Royal Oak Roundabout Safety Improvements

Road Safety Review
Scheme/Preliminary Design

May 2018

Figure 3 Vicinity map showing wider network route options

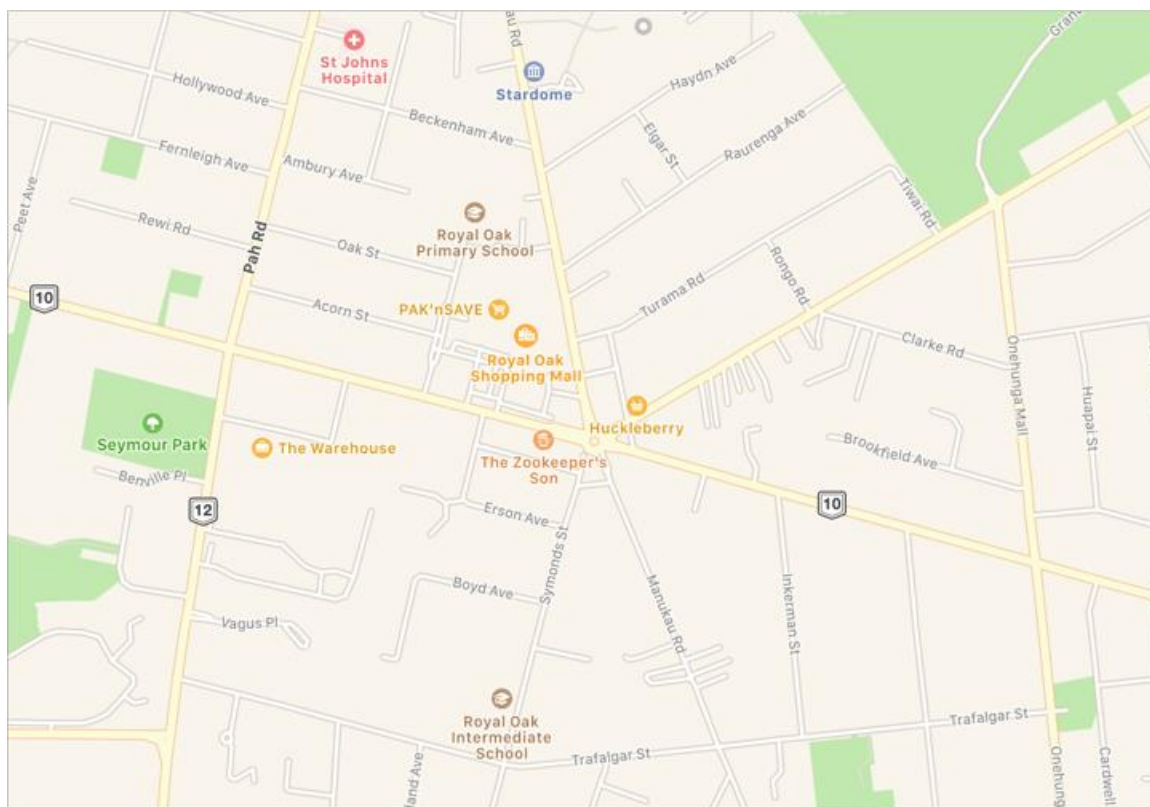
At a conceptual design stage, it is also appropriate to consider alternative forms of access or control and their relative safety performance. For example, other treatments could include reconfiguration to a signalised intersection, alternative roundabout configurations or alternative routes and way-finding measures to bypass this site and divert some traffic demand.

In the project briefing meeting it was mentioned that other central island shapes have been considered, as well as removing an exit lane on Mount Albert Road, a turbo-roundabout treatment with kerb-separated circulatory lanes, and staggering the pedestrian crossings. The possibility of a subsequent urban design study that included consideration of a raised shared space on Campbell Road leg with a driveway apron treatment at the roundabout was also discussed, as well as possible bypass alleys or streets.

Therefore, without further information the reviewer is reluctant to opine on whether the form and location of the roundabout is the best solution in terms of a safe system design for this specific location. However, in general terms, it should be noted that a well-designed multi-lane roundabout can provide an appropriate safe system design for an intersection.

At an appropriate time, consider a project scoped to focus on urban design and the relative merits of alternative roundabout configurations and/or alternative network options and/or control, to improve safety performance.

Appendix A: Roundabout Improvements Concept Design

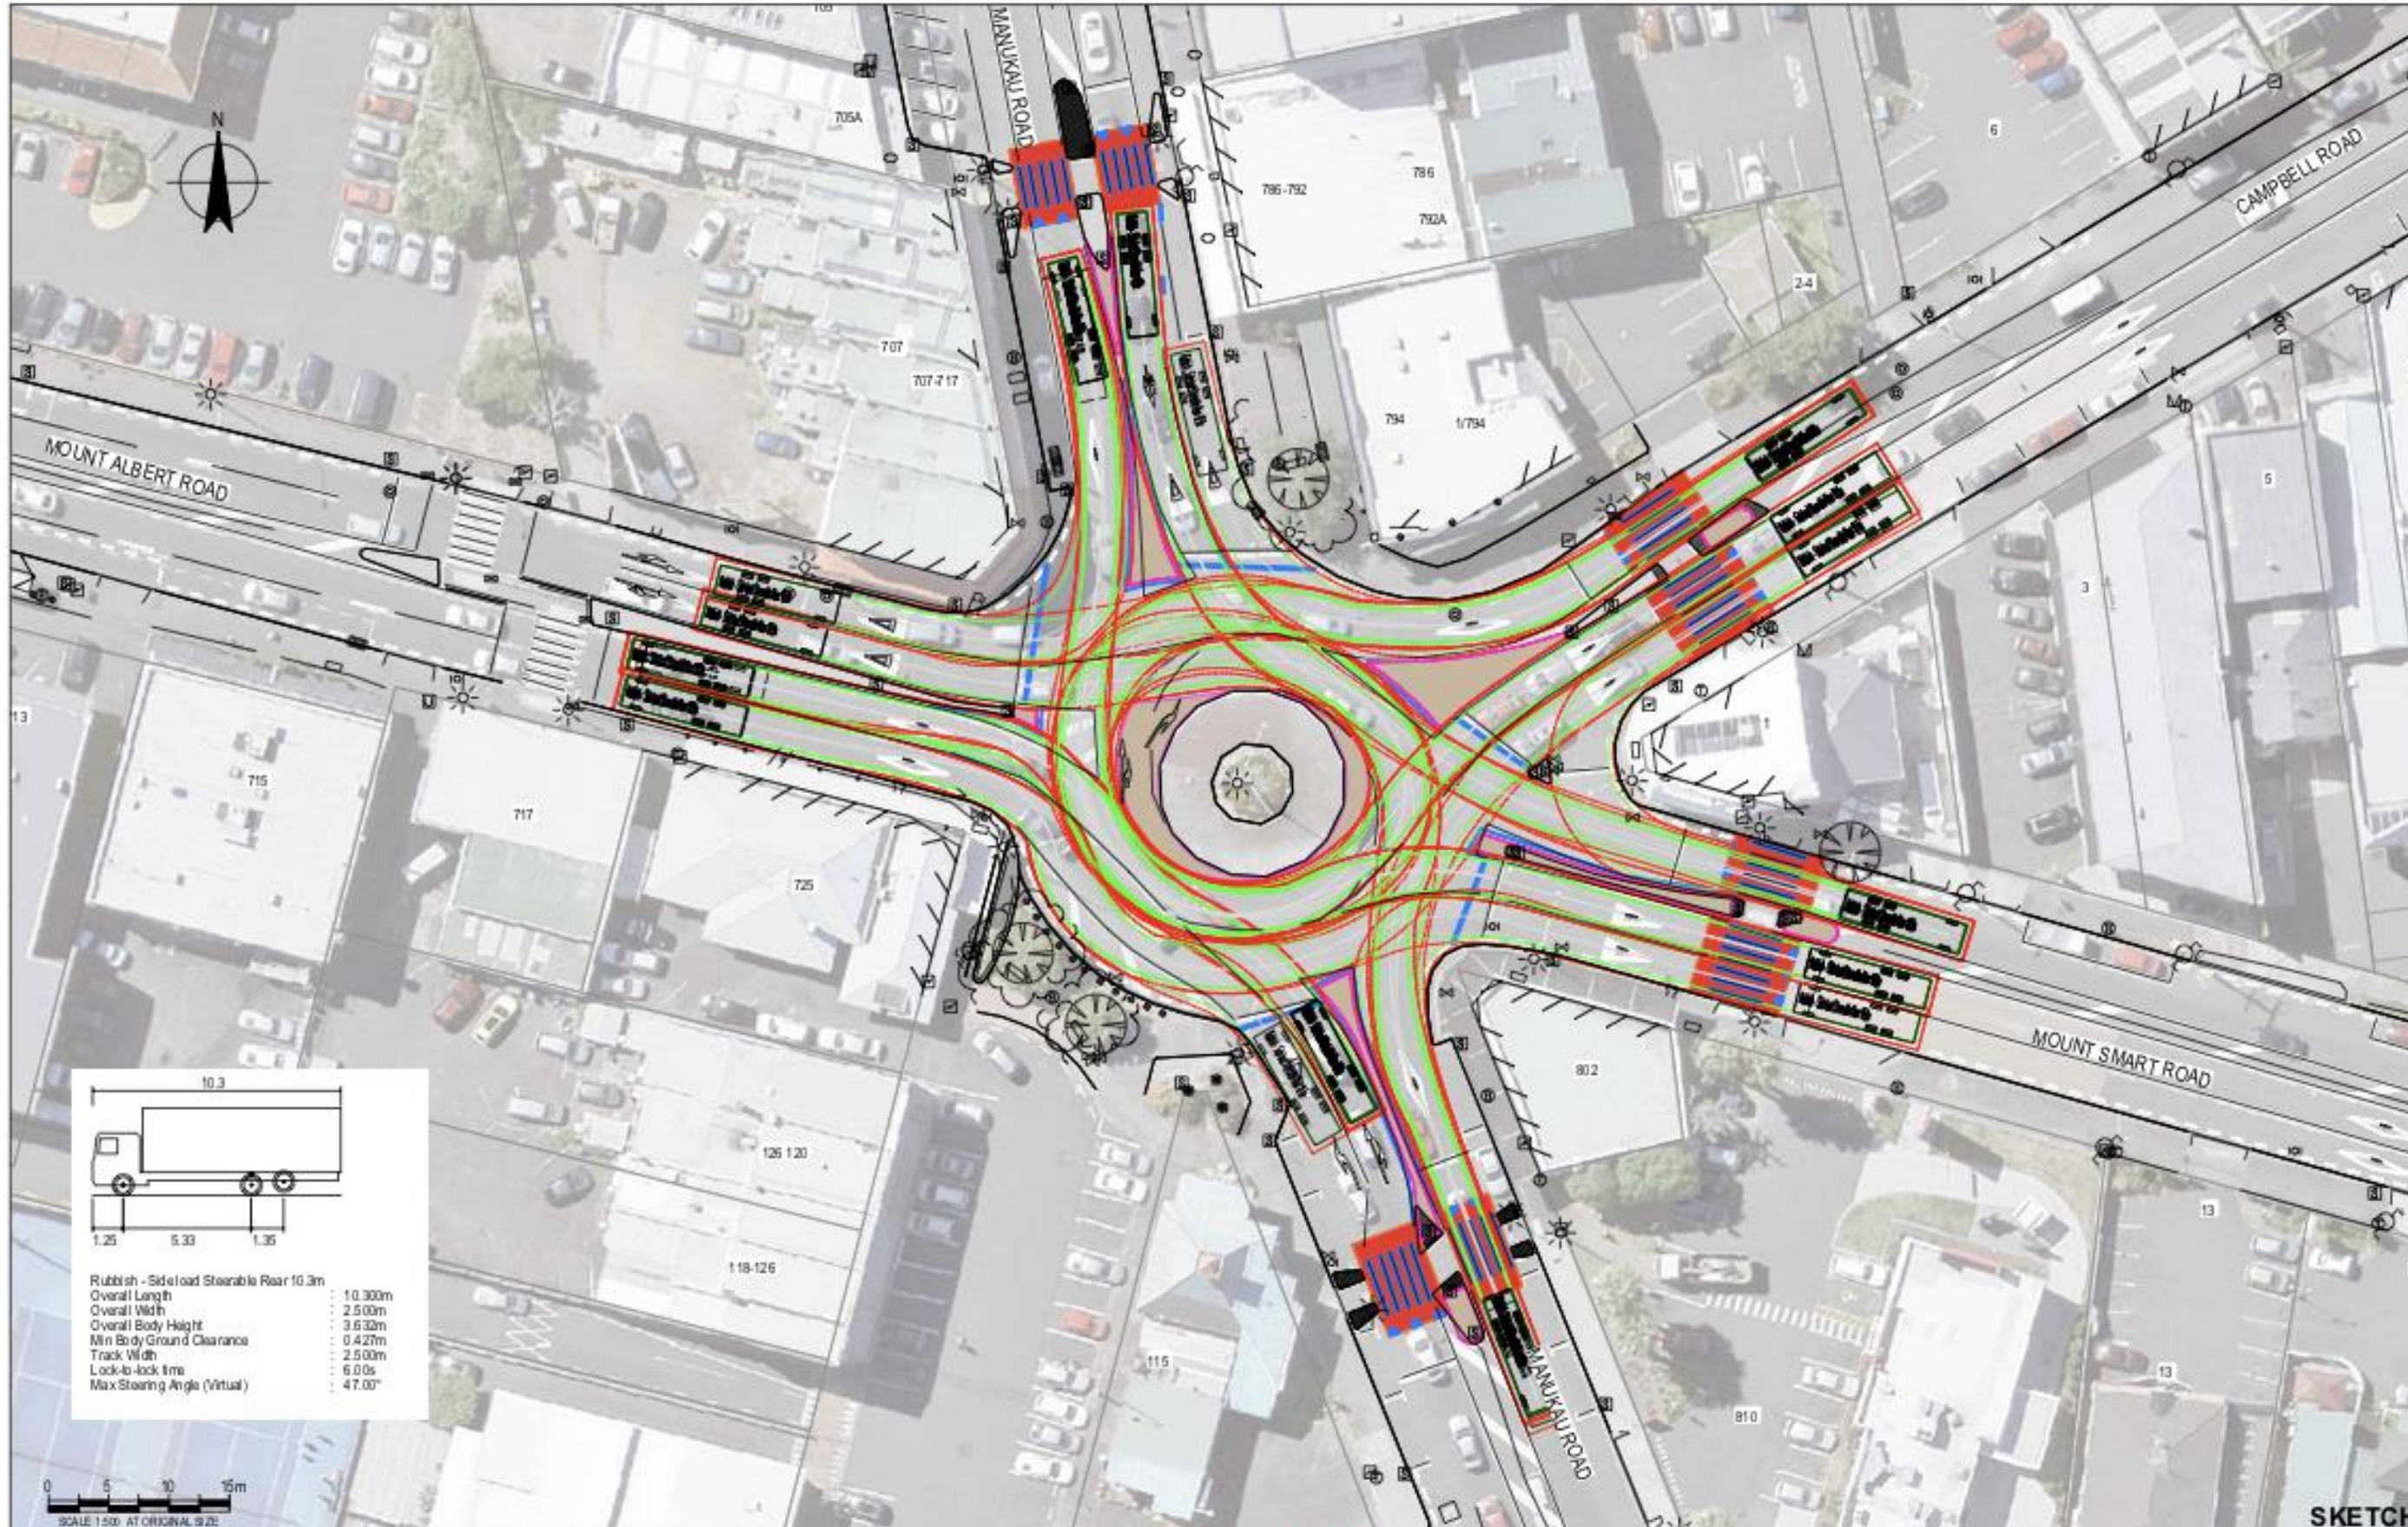
The proposed design shows that all of the current double-lane entry lanes only serve between 1 and 3 of the possible 5 exit legs and the circulatory roadway lane is restricted to two lanes at most. This makes it even more important than in the current design that vehicles are correctly pre-segregated into the correct entry lanes, even prior to the pedestrian crosswalks so that unsafe late lane changing is minimised. In this regard, Advanced Directional Signs with individual lane origin-destinations have been proposed. Also, three approach lanes downstream of the crosswalks have been marked with solid lines to indicate that no lane changing should occur. Three of the 5 approaches have repeated the entry lane turn arrows upstream of the crosswalks.

However, the positions of the ADS in terms of upstream location distance appear to be shorter than optimal, given the extensive queuing that occurs on the approaches during peak periods. Ideally, drivers should not be required to change lanes in-queue but rather be forewarned with enough time and space in terms of lane changing indications or gaps to pre-segregate their vehicles prior to joining the back-of-queue.

The entries into the roundabout appear to be perpendicular to the central island and have relatively low deflection. Thus, it is possible for drivers to enter the roundabout at inappropriately high speeds and they may then be forced to slow quickly into the circulatory lane. This could increase the likelihood of loss of control. Specifically, the inside entry lanes closest to each splitter island are not oriented tangentially to the central island truck apron. At unconstrained sites, best practice is to offset the approach entry paths to the left of the central island (including any apron) to manage entry speeds into the circulatory roadway with the minimum vehicle speed being achieved at the roundabout limit line. This can generally be achieved geometrically by resetting of the splitter island leading edge and the

The design has circulatory lane markings spiralling out from the cams on the central island to the Mount Albert Road exit and the Campbell Road exit. As critical as ensuring the correct exit paths are taken is ensuring that the correct entry paths from the giveway lines to the correct circulatory lanes are made. Therefore the design could be improved by providing these guide markings for the inside lanes leading from all entries except Manukau Road northbound where it is not needed.

The proposed design shows solid lane markings in the southwest and northeast quadrants of the circulatory roadway, similar to the raised kerbs in a Dutch “turbo” roundabout design. These lane markings are intended to be mandatory and enforce lane-discipline. As such they should be bold, and possibly treated with a different colour or possibly using audio-tactile pavement markers.

- a) Re-locate the ADS signs as far upstream on each approach as required to allow for safe lane changing prior to joining the back of queues during peak periods;*
- b) Provide repeated turn lane markings upstream of peak period queues on each approach to encourage pre-segregation;*
- c) Extend solid lane lines on Mount Albert Road approach upstream of the pedestrian crosswalk to discourage late lane changes.*

- a) *At detailed design stage, assess the speed path profiles through the roundabout and provide for safe speeds: through both the entry and circulatory path, with the inner entry lanes being sufficiently offset from and as tangential to the central island as possible; to reduce path overlap for through traffic entering at Campbell Road and Mount Smart Road, and to reduce speeds on the tangential exit lanes at Campbell Road and Manukau Road south exit.*
- b) *Design the mountable central island apron kerb to be sufficiently offset from the fastest travel paths and flush with the pavement surface to minimise the tripping hazard for motorcyclists;*
- c) *Correct the geometry to avoid an exit lane path overlap conflict point for heavy vehicles at Mount Albert Road exit;*

- a) *Consider providing guidelines for the median entry lanes from the giveway line into the correct inside circulatory lane for critical movements.*
- b) *Consider providing turning lane arrow markings in front of the splitter islands in the multi-lane circulatory roadway.*
- c) *The solid spiral lane markings in the southwest and northeast quadrants of the circulatory roadway could be made more conspicuous through a combination of wider and different colour and/or by including audio tactile pavement markings.*

Sheet No.	A3																								
Drawing No.	51-37315-0203-SK018																								
Rev.	A

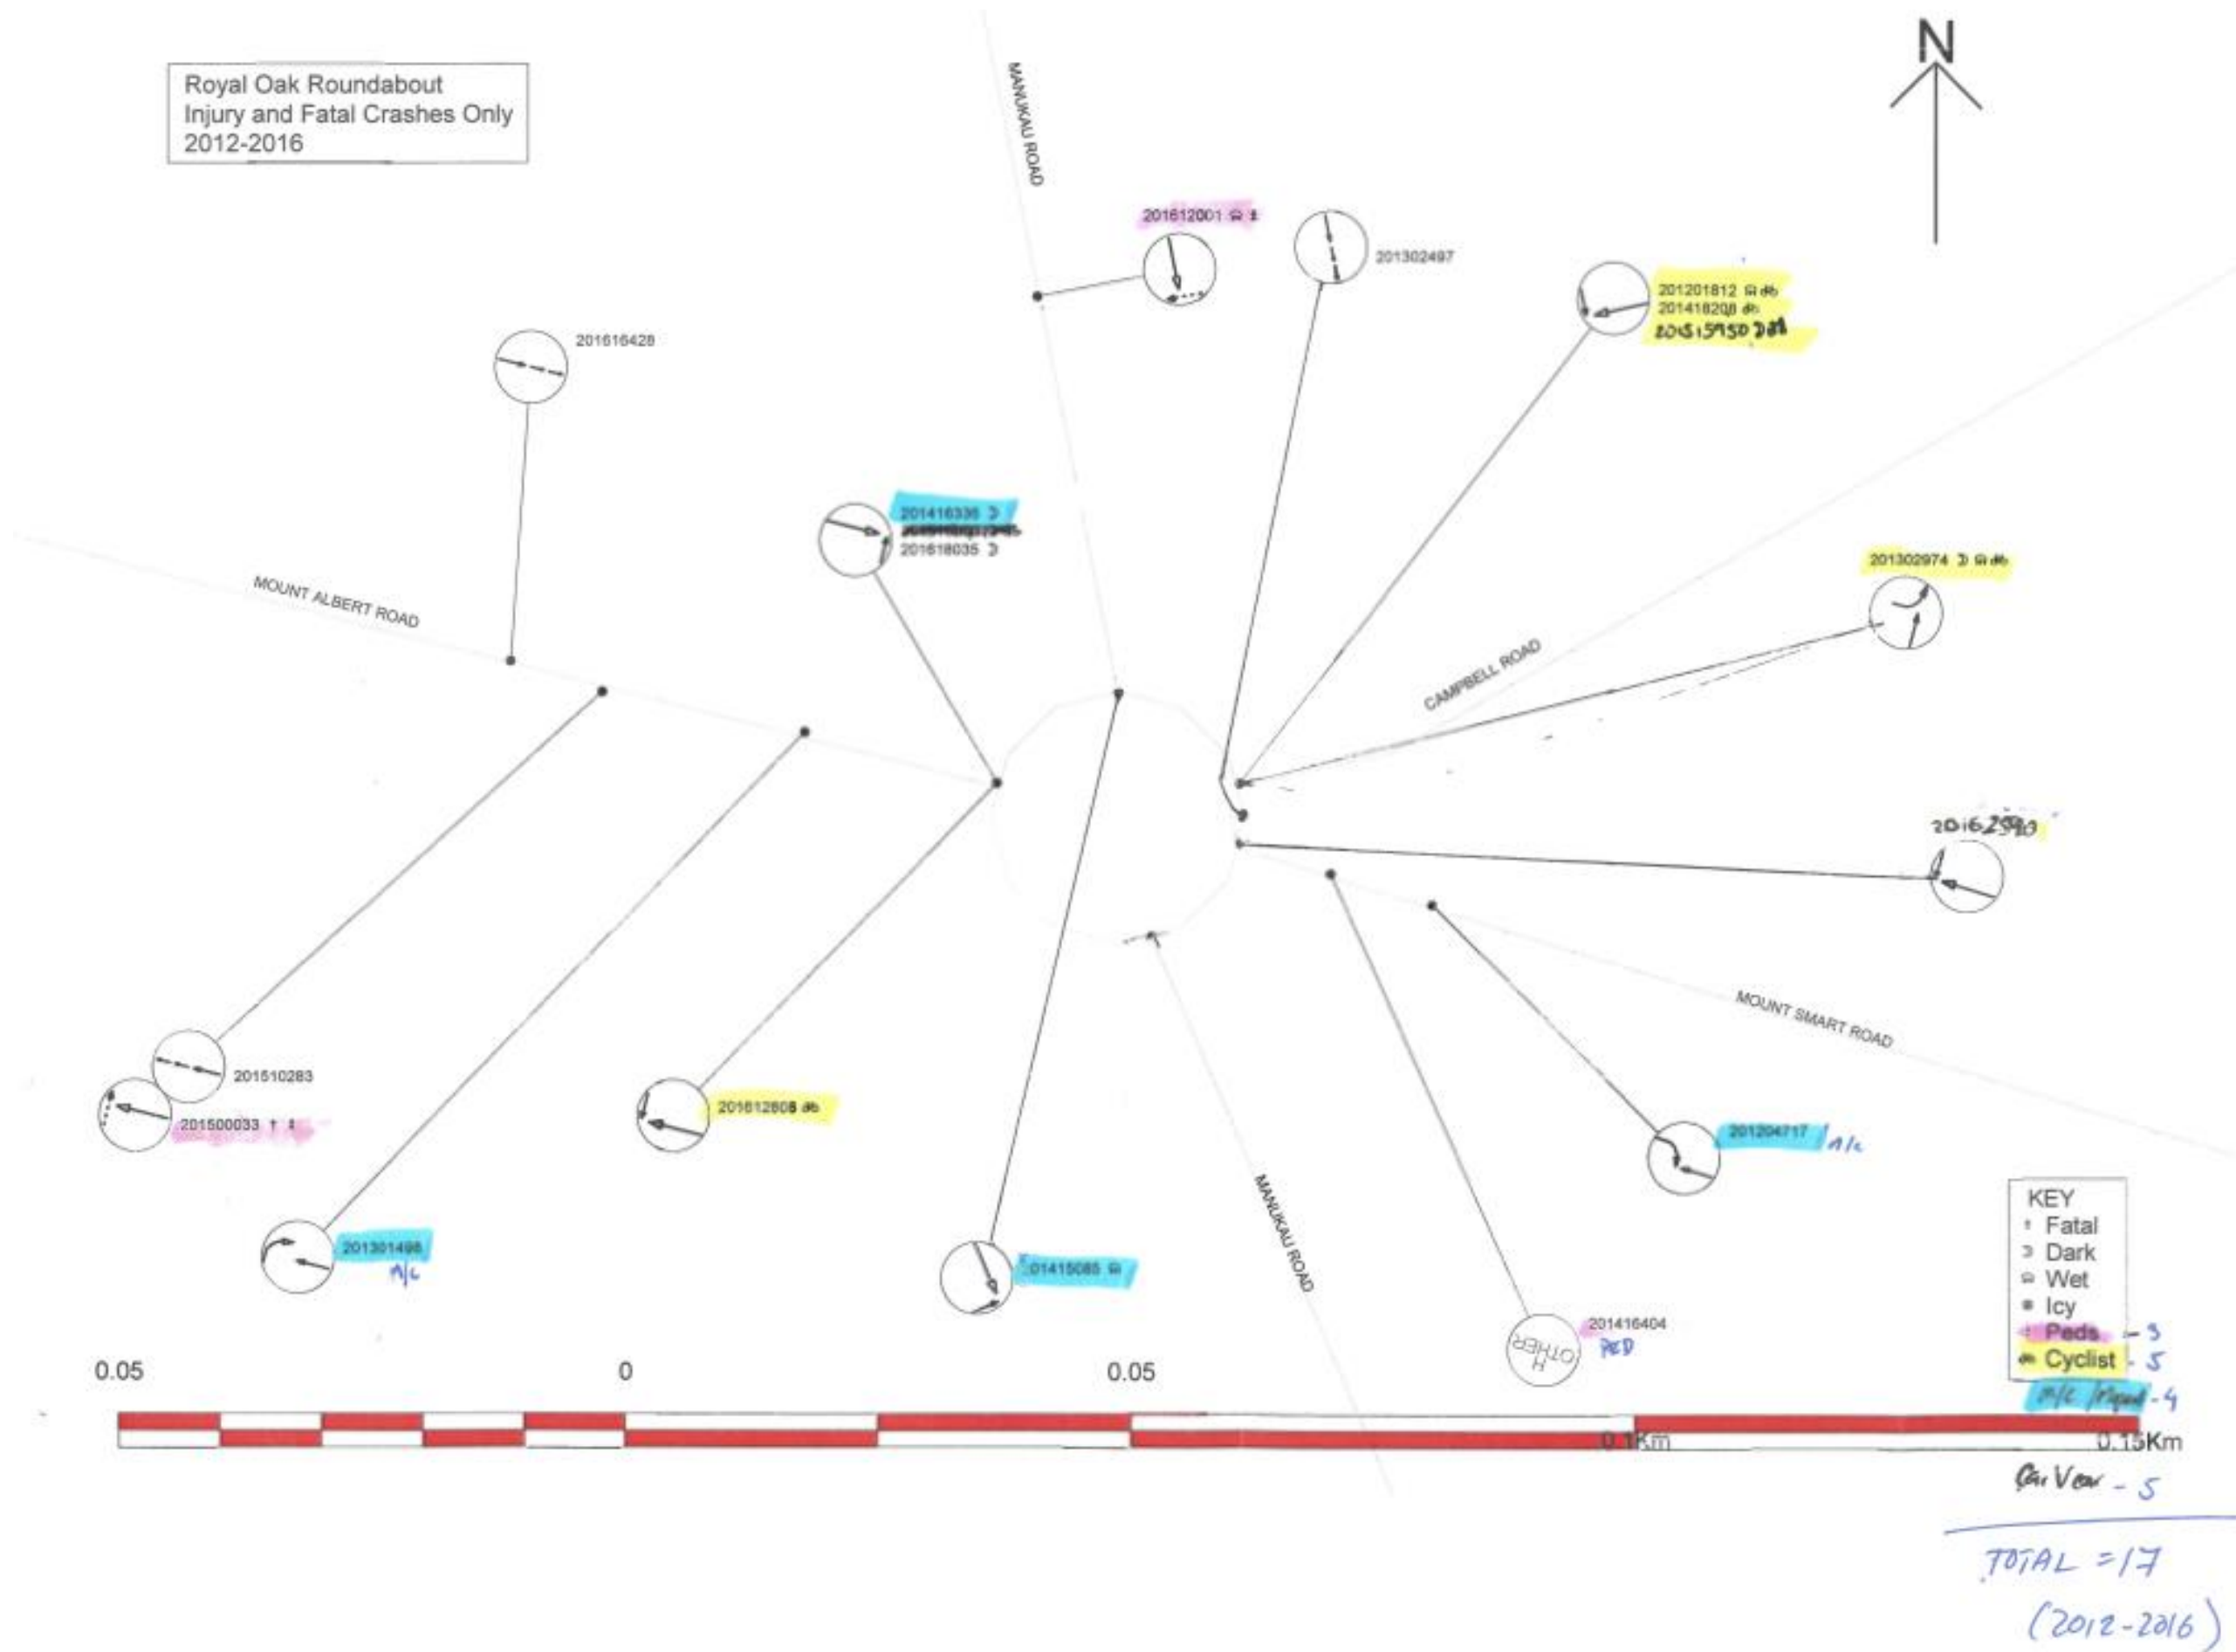
On the other hand, on multi-lane exits, perpendicular exits can cause exit path overlap, particularly for heavy vehicles. For example, the double lane exit to Mount Albert Road has a severe left turn on exit arrangement which adjacent trucks or buses are unable to negotiate without crossing the exit lane markings (see swept paths in Appendix B). This will lead to side-swipe conflicts and crashes.
